SUBJECT: CALVERT CLIFFS NUCLEAR POWER PLANT, UNIT NO. 2 - REQUEST FOR  
ADDITIONAL INFORMATION REGARDING RELIEF REQUEST RR-ISI-04-07A,  
"DISSIMILAR METAL BUTT WELDS BASELINE EXAMINATIONS" (TAC NO.  
ME8871)

REQUEST FOR ADDITIONAL INFORMATION  
REGARDING RELIEF REQUEST RR-ISI-04-07A  
CALVERT CLIFFS NUCLEAR POWER PLANT, LLC.  
CALVERT CLIFFS NUCLEAR POWER PLANT, UNIT NO. 2  
DOCKET NO. 50-318

Figure 1 Top View of 2D Matrix Array Depicting Separation Dimension

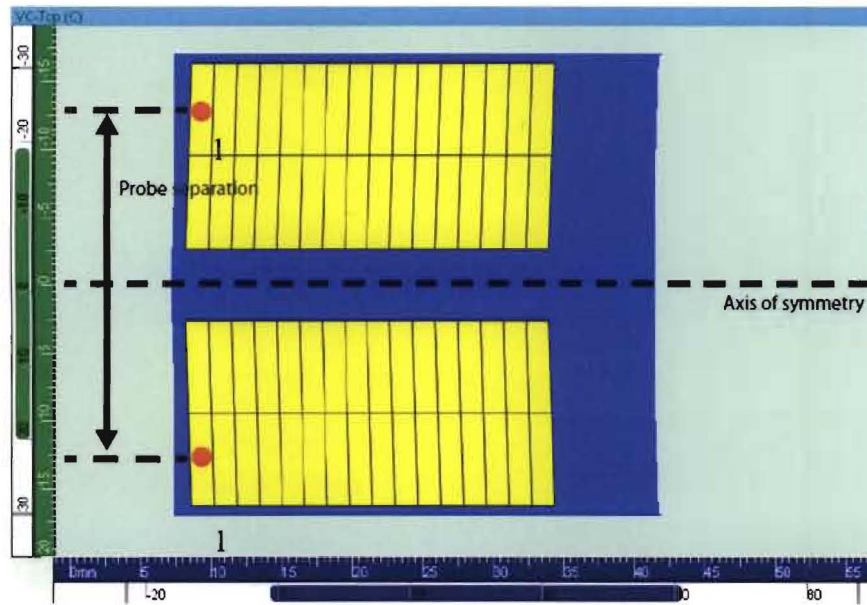
2. Physical separation between arrays (if TRL/TRS configuration). Identify distance between first element of one array and first element of second array (array separation—see Figure 1).

Figure 2 Top View of 2D Matrix Array Depicting Primary and Secondary Axis Pitch Dimensions

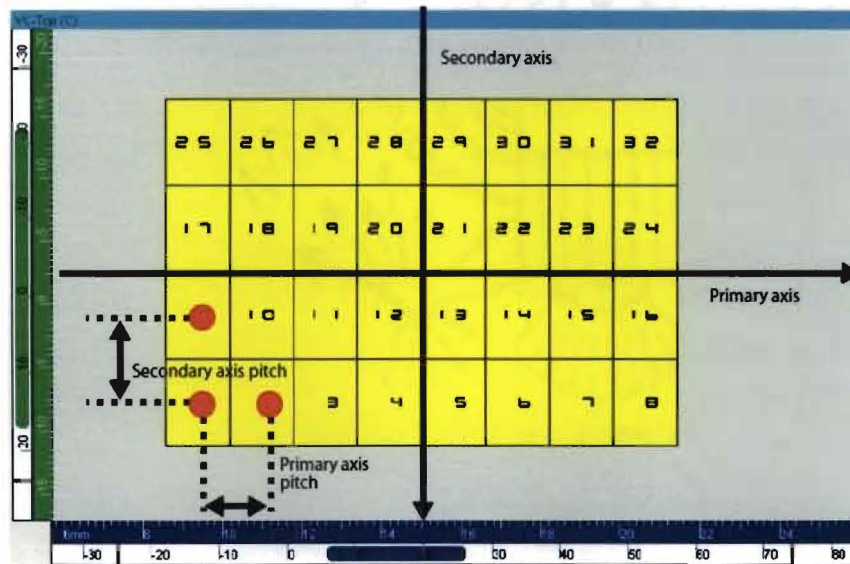
2. Number of elements along the secondary axis.
    - v. Element dimensions along primary and secondary axes, spacing between elements, and center-to-center distance (pitch—see Figure 2):

Figure 3 Definition of Wedge Angle

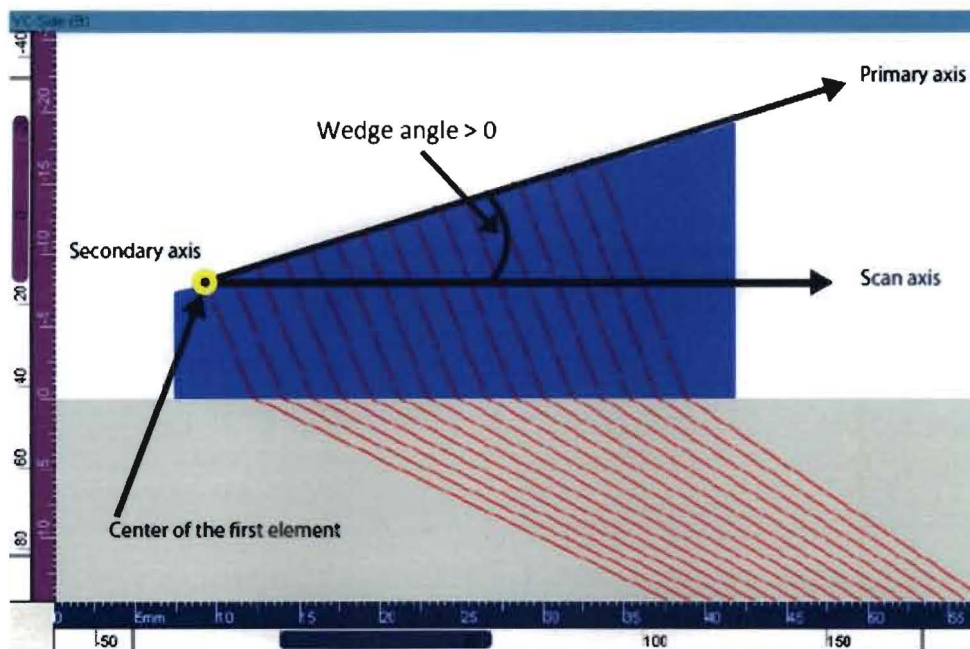
- c. Wedge (see Figure 3):
- i. Material type—Rexolite, other, etc.
    1. Longitudinal and shear wave velocity.
    2. Attenuation.
    3. Density.
  - ii. Geometry:

1. Wedge angle.
    2. Roof angle (if used).
    3. All physical dimensions necessary to create 3-D solid model, such as height at front of wedge, height at back of wedge, width of wedge, and length of wedge

Figure 4 Beam Focusing Options for Phased Array Probes

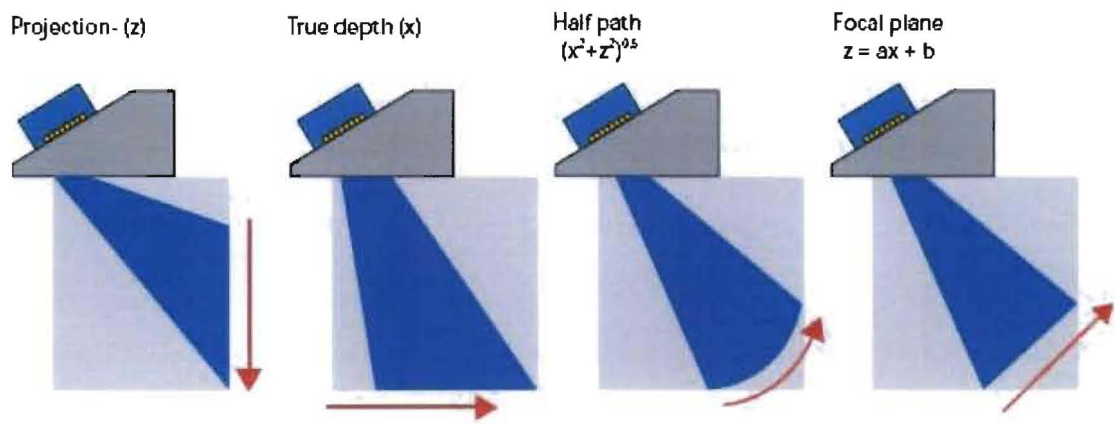
- d. Beam focusing:
- i. The type of focusing technique is needed as well as the specific parameters associated with each type. The four types of focusing techniques are listed below and shown graphically in Figure 4. State the type of focusing used and include associated details, as listed below:
